### **Meadowbank MDRB Report No 25A**

Report No 25A  
Meadowbank Mine Dike Review Board  
Meetings September 9-11 and November 26, 2019

## **RESPONSE TO COMMENTS, MEADOWBANK DIKE REVIEW BOARD No.25 – MEADOWBANK REPORT**

Photo No. 1 Bay-Goose Pit

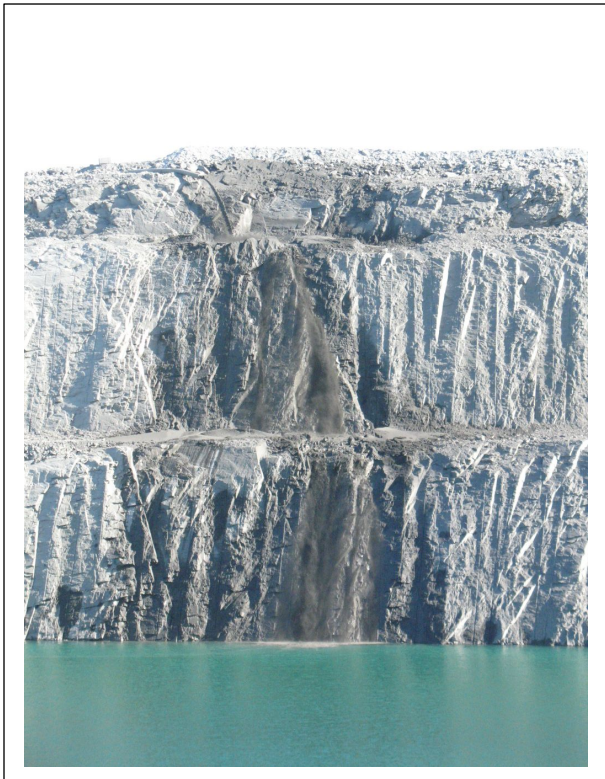
Since February, 2019, tailings have been discharged from the top of the eastern high wall of the Bay-Goose pit. See photos Nos. 1 and 2. With a composition of approximately 55% water and 45% solids. Water was also pumped from the seepage pond (photo No. 4) at Central Dike, the resulting tailings deposit is entirely sub-aqueous. The Board suggests that bathymetric surveys be conducted on a regular basis in order to determine the in-situ density and topography. At meeting No. 24 (2018), there was discussion pertaining to the consolidation rate of the sub-aqueous tailings and its effect on permeability that that would control seepage through the deposit. A bathymetric survey would add to the database and improve long term understanding of in-situ conditions.
